Model: MT-C5	Date: 17-May -12	No.: RD131001a
--------------	------------------	----------------

Subject: Firmware Release Note: RPCS		Prepared by: M. Yoneda	
From: 2nd Tech Service Sect., MFP/Printer Tech Service Dept.			
Classification:	<input type="checkbox"/> Troubleshooting <input type="checkbox"/> Mechanical <input type="checkbox"/> Paper path <input type="checkbox"/> Product Safety	<input type="checkbox"/> Part information <input type="checkbox"/> Electrical <input type="checkbox"/> Transmit/receive <input checked="" type="checkbox"/> Other (Firmware)	<input type="checkbox"/> Action required <input type="checkbox"/> Service manual revision <input type="checkbox"/> Retrofit information <input checked="" type="checkbox"/> Tier 2

This RTB has been issued to announce the firmware release information for the **RPCS**.

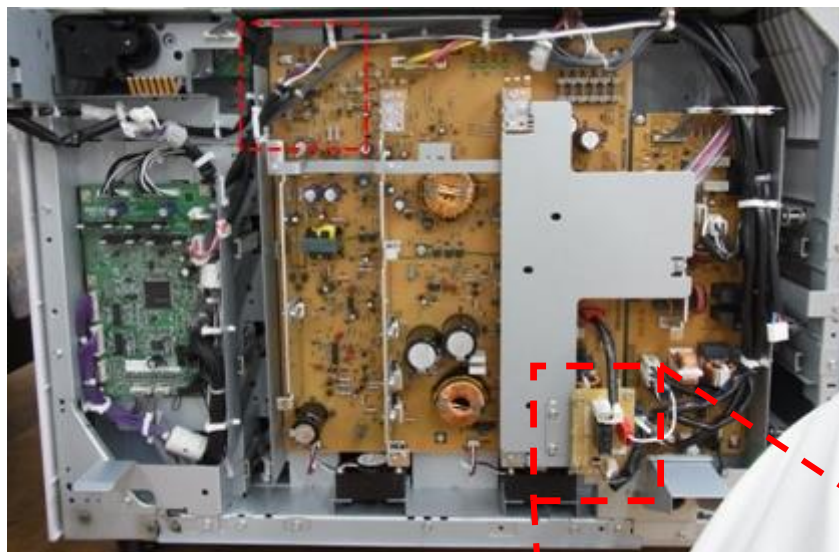
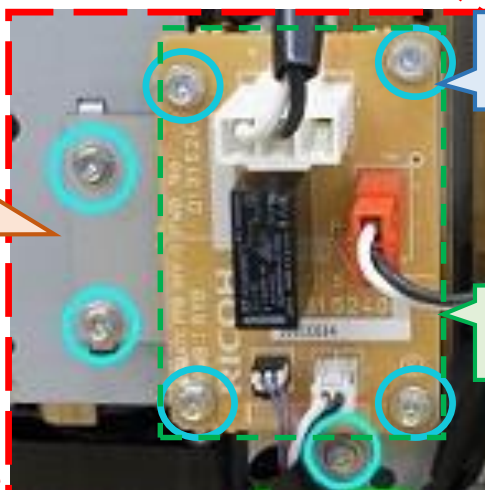
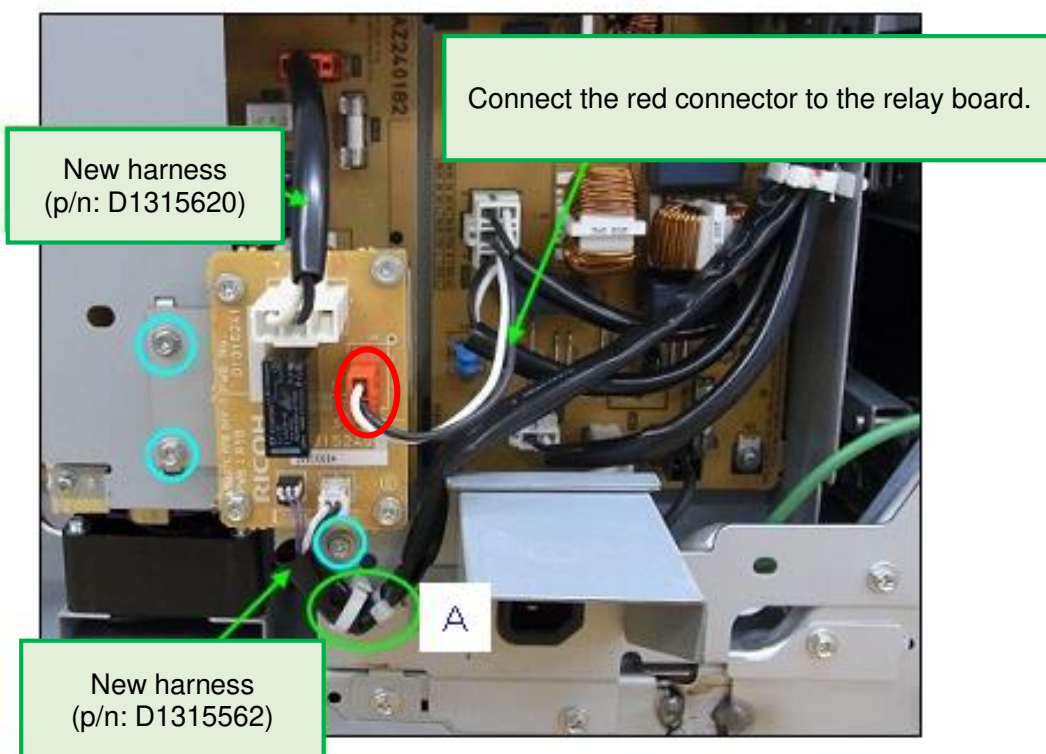
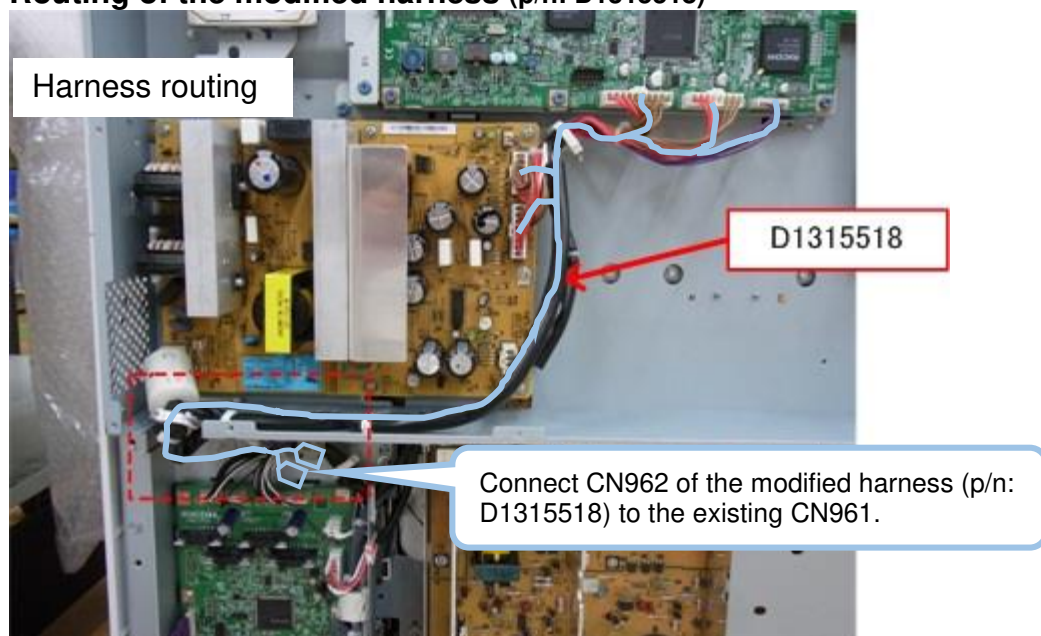
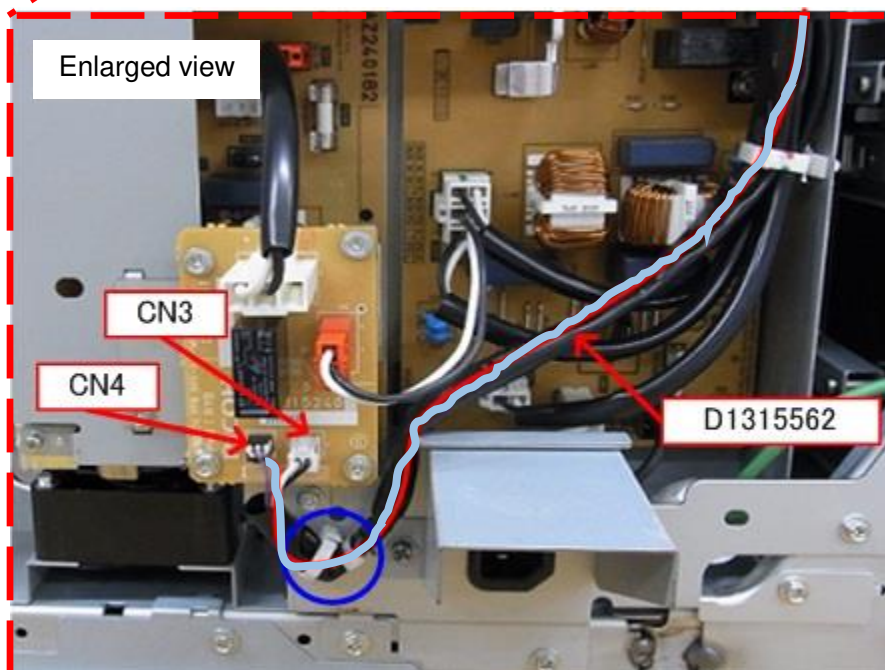
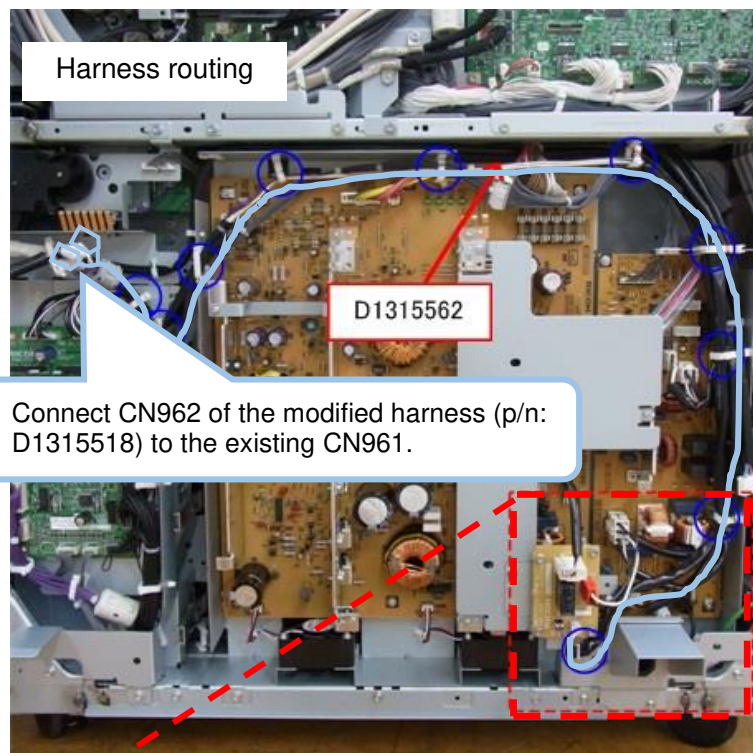
- Relay board (and bracket for the relay board) were added.
- Two harnesses were modified.
- Two harnesses were newly added.

Reason: To further reduce power consumption during Sleep Mode

- Cut-in S/N information for this modification is unavailable. If the machine is installed with the new relay board (RYB, p/n: D1315240), it is of the modified type.
- **Installing the new RYB in a machine manufactured prior to this modification will not reduce power consumption during Sleep Mode. Refer to this bulletin only when any of the above parts need to be replaced.**
- Old harnesses (p/n: D0625561, p/n: D0625517) do not have to be replaced with new ones (p/n: D1315562, p/n: D1315518) on machines manufactured prior to this modification. Old harnesses will continue to be supplied.

How to connect the two modified harnesses (p/n: D1315518, p/n: D1315562)

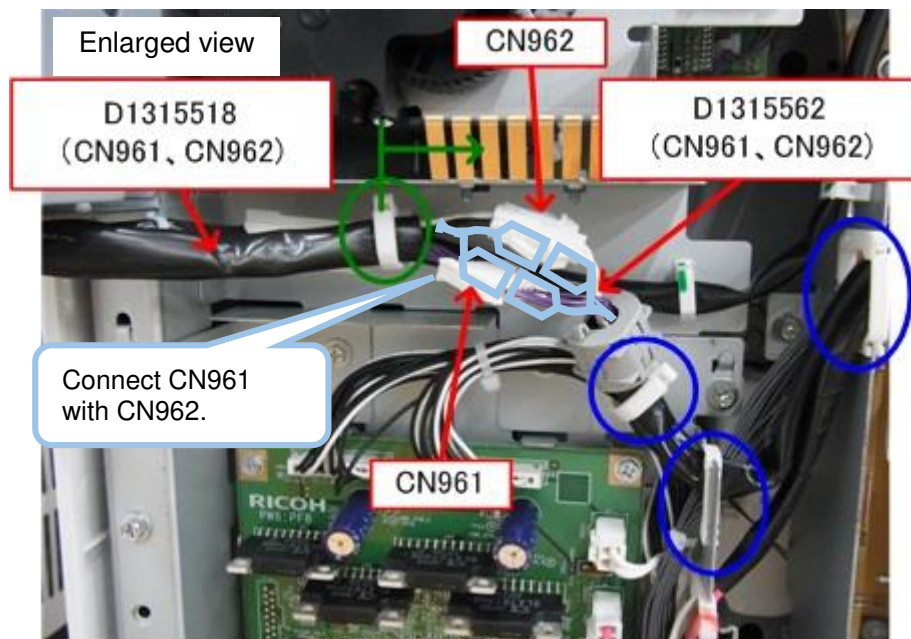
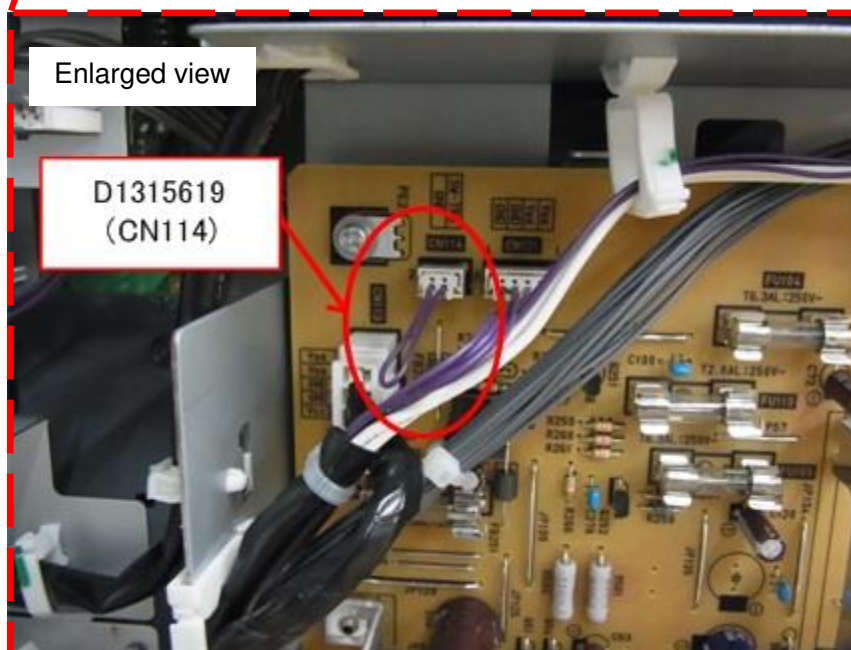
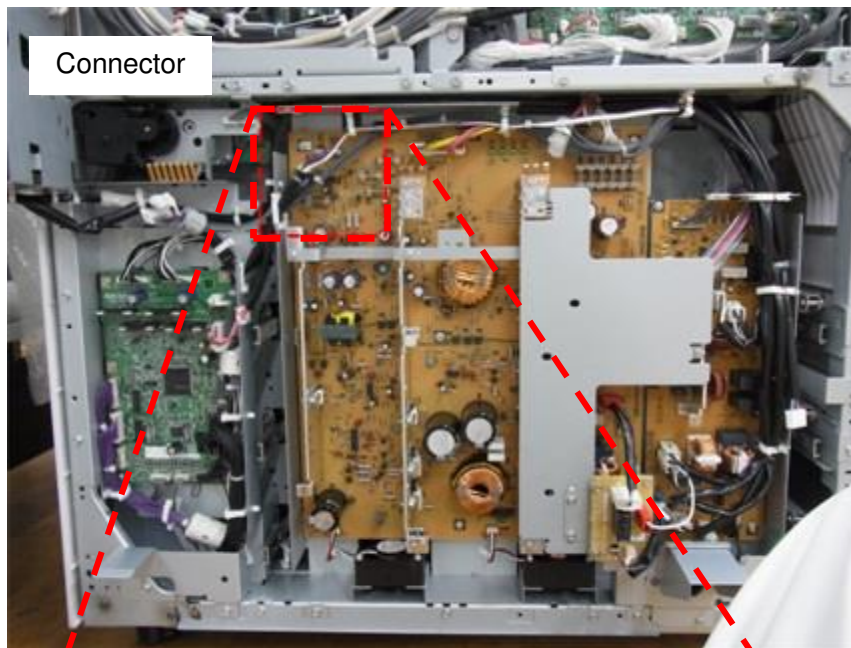
Newly added harness (p/n: D1315619)

Connection to CN114 is shorted with the new harness (p/n: D1315619).

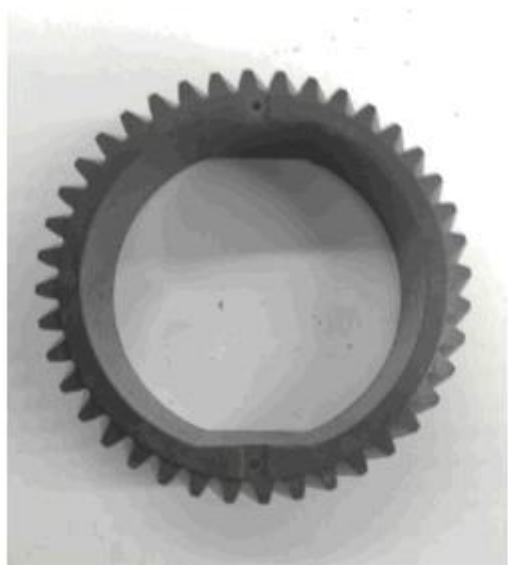
The material of the part is changed and the size of the part is made more accurate to prevent it from breaking or wearing out.

The color is changed due to change of the material.

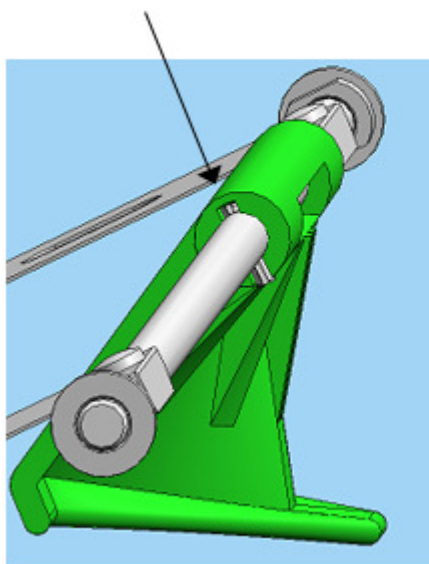
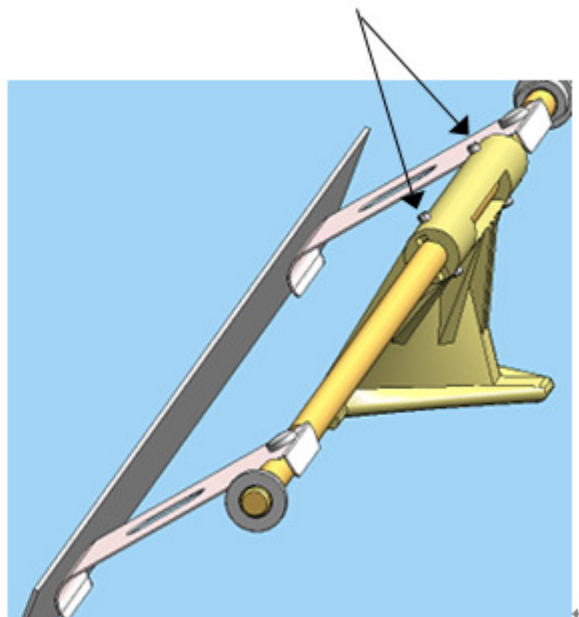
The shape is changed to prevent it from breaking.

This part was broken.

Two spring pins is added.

Old part number	New part number	Description	Q'ty	Int	Page	Index	Note
B0654422	D1314421	SHAFT:PRESSURE:GUIDE PLATE:ASS'Y	1	X/O	119	12&13	-
